NOTICE OF DENIAL

RE: Application Number 22-8159; 4762 Cortland.; Russell Woods-Sullivan Historic District

CERTIFICATE OF APPROPRIATENESS

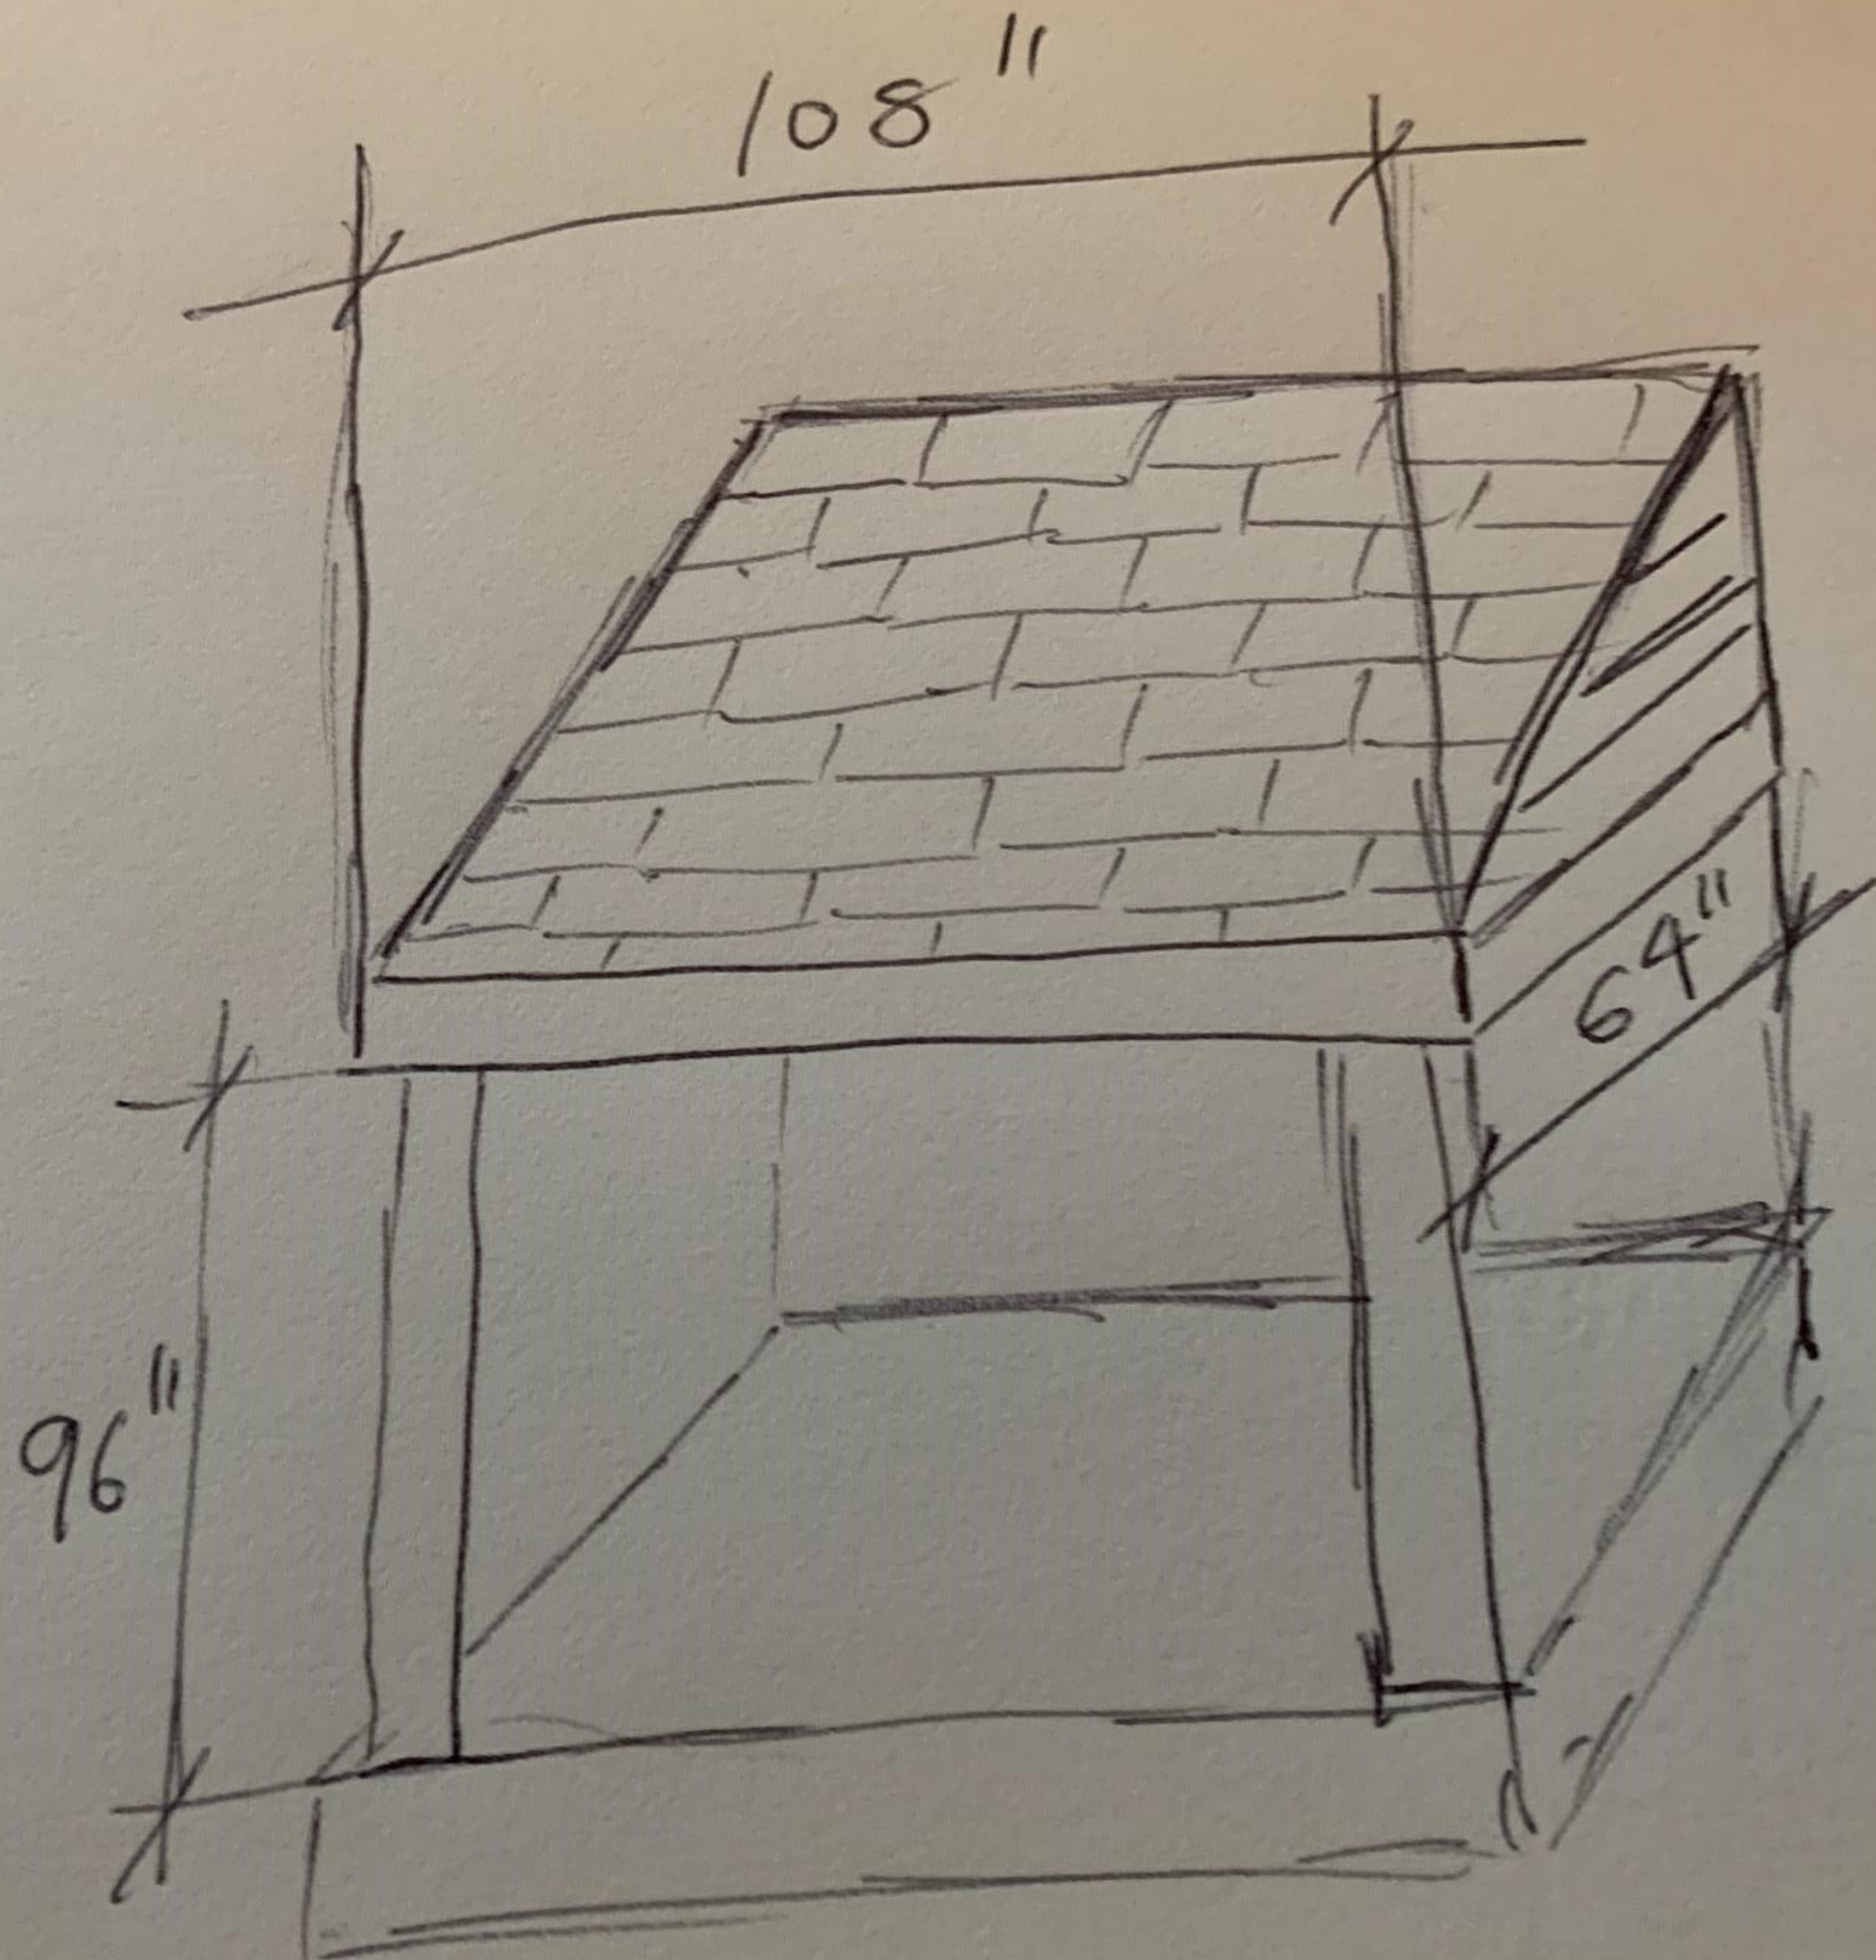
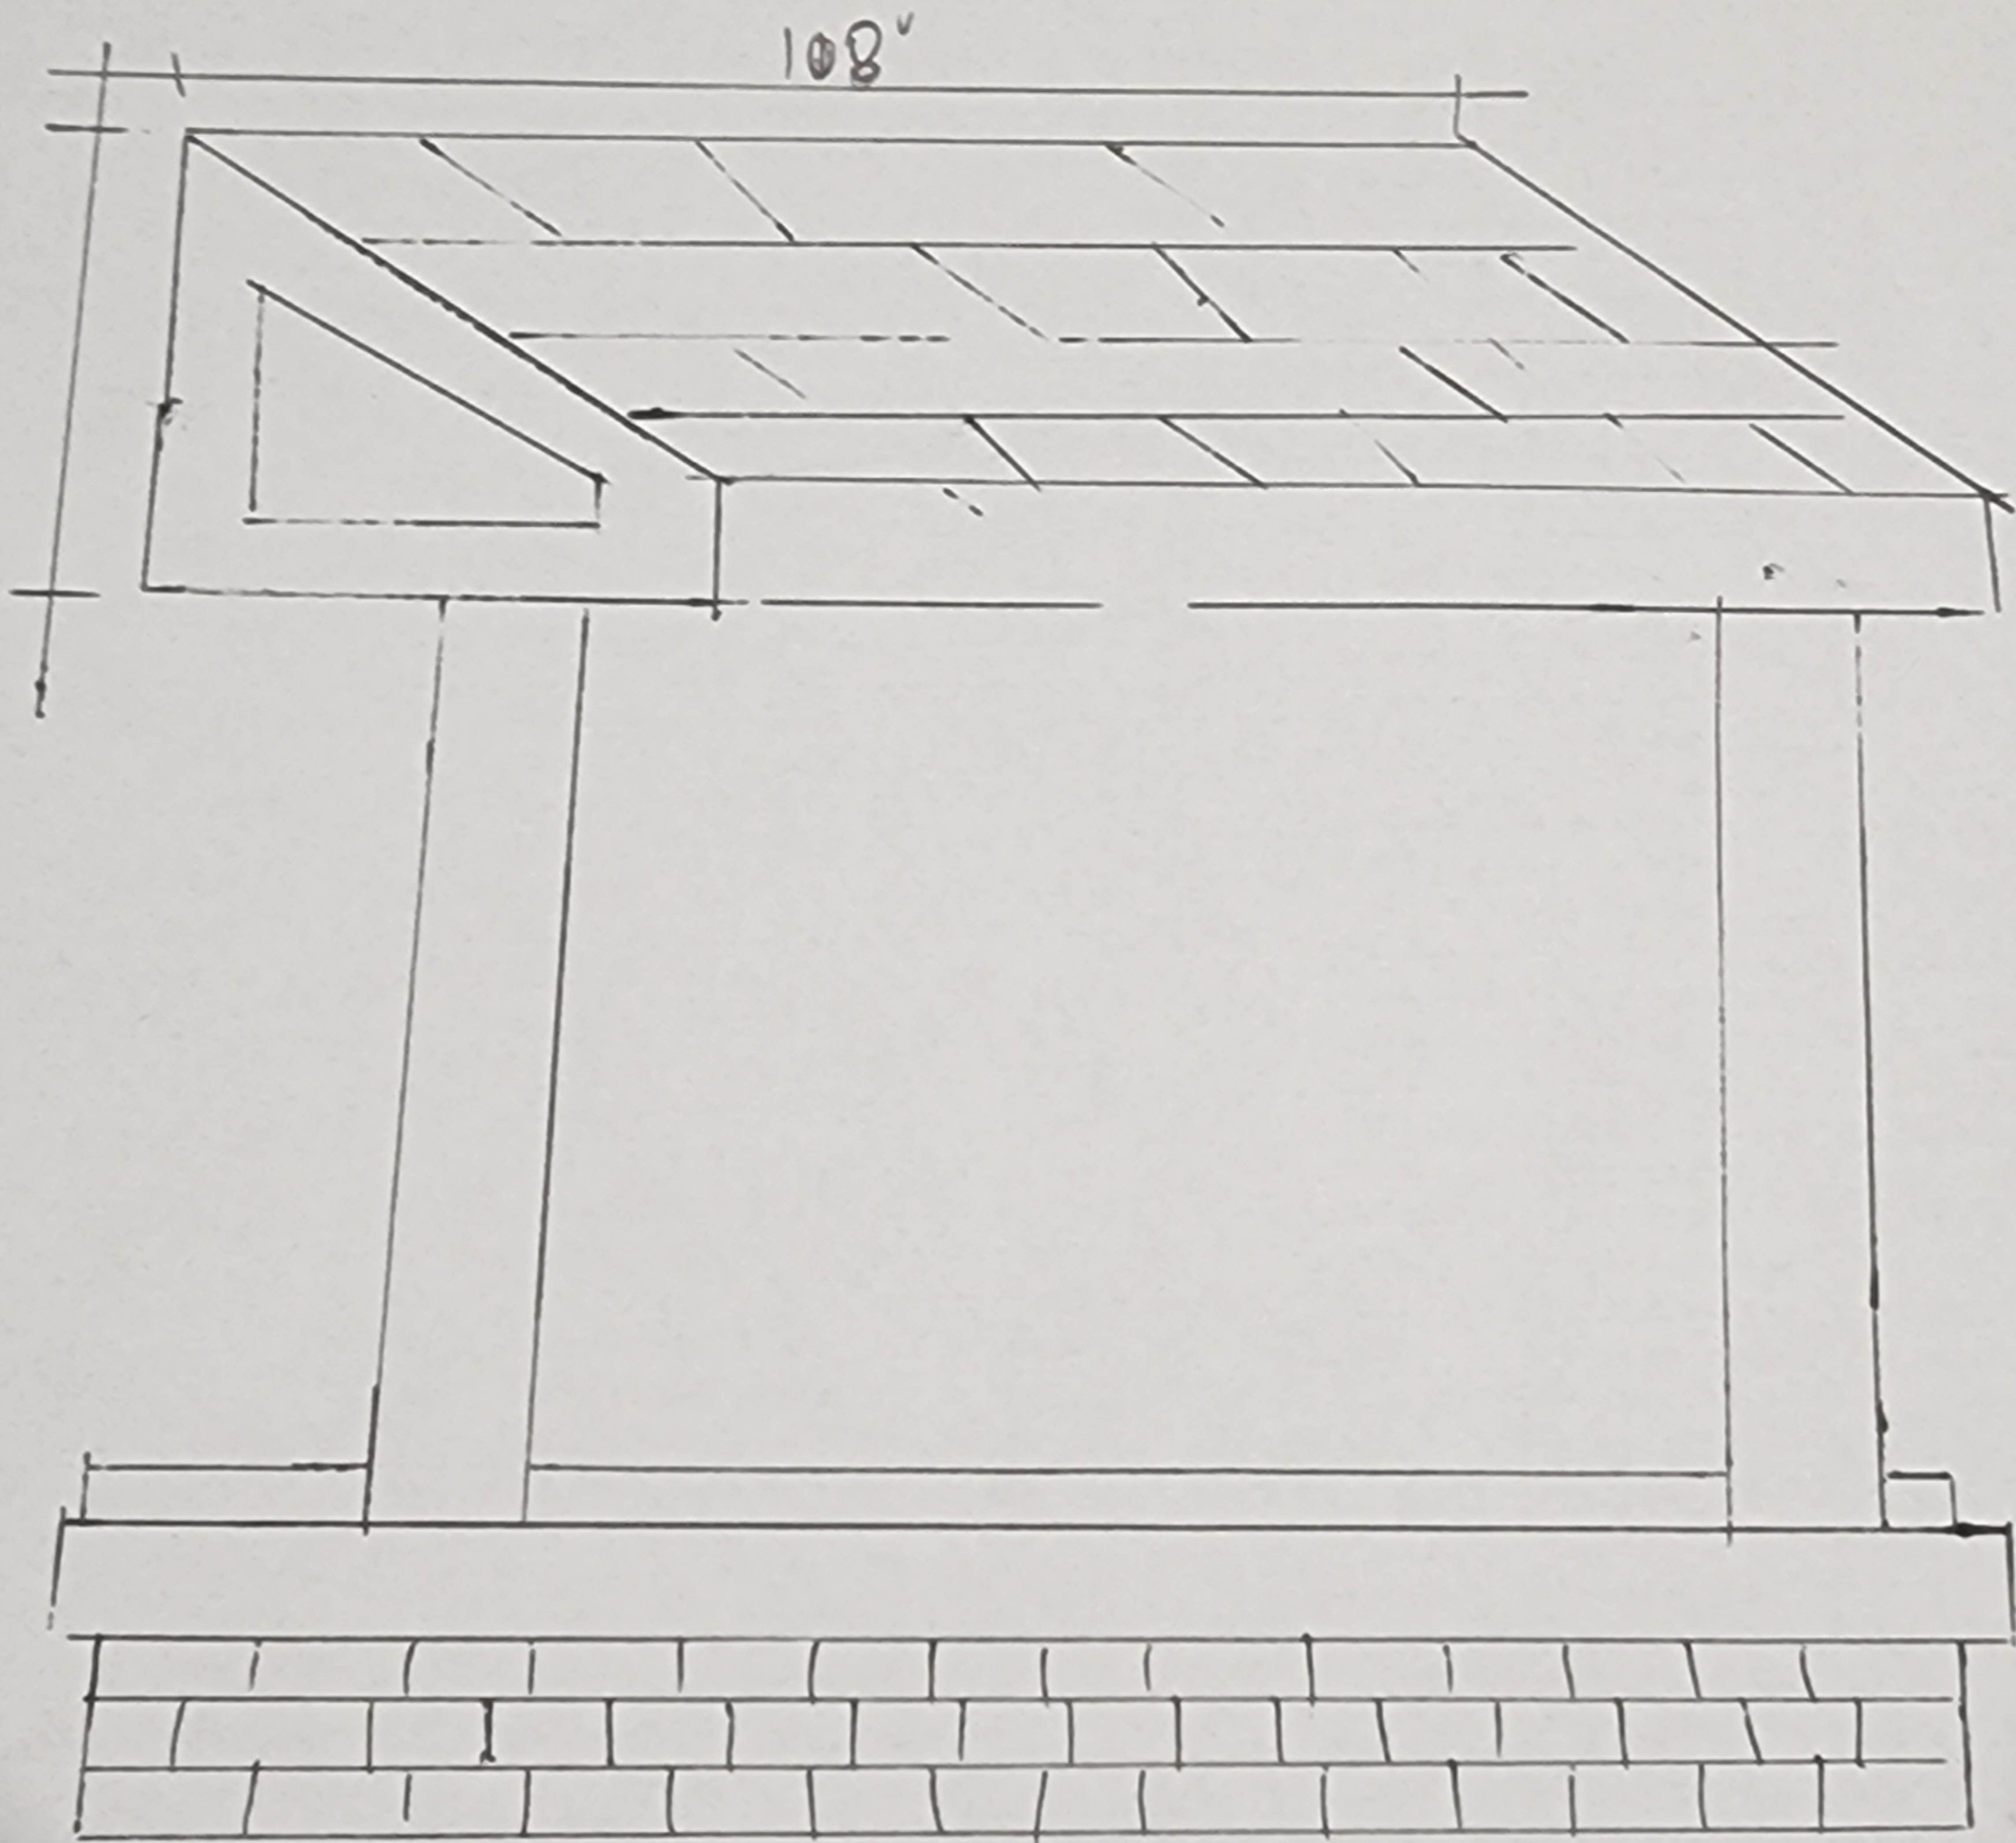
- 1) The similar design and style windows proposed for approval will be manufactured with wood instead of fiberglass. As suggested at the meeting.
- 2) The detail of the front entrance trim is seen in pictures 1 and 2. The trim will be rehabilitated and returned to its original condition.

- 3) The repair of the front porch will be carried out as I have explained and got the preapproval from the commission members at the Regular Meeting that was held on December 14, 2022. According to our proposal, we are planning to build a shed roof as seen in pictures 4 and 5. We will use the same asphalt shingles for the roof cover, and pillars and other elements will be painted in white to match the building color. We will use only wood material.

- 4) The design and material for the lower panels of the front elevation windows will be SmartSide 76 Series Cedar Texture Panel 8 in. OC Engineered Treated **Wood Siding**, Application As 4 ft. x 8 ft. The material will be painted white. See Picture 3

- 5) For the front door, we will refurbish the door; you may see its image attached in pictures 6 and 7.
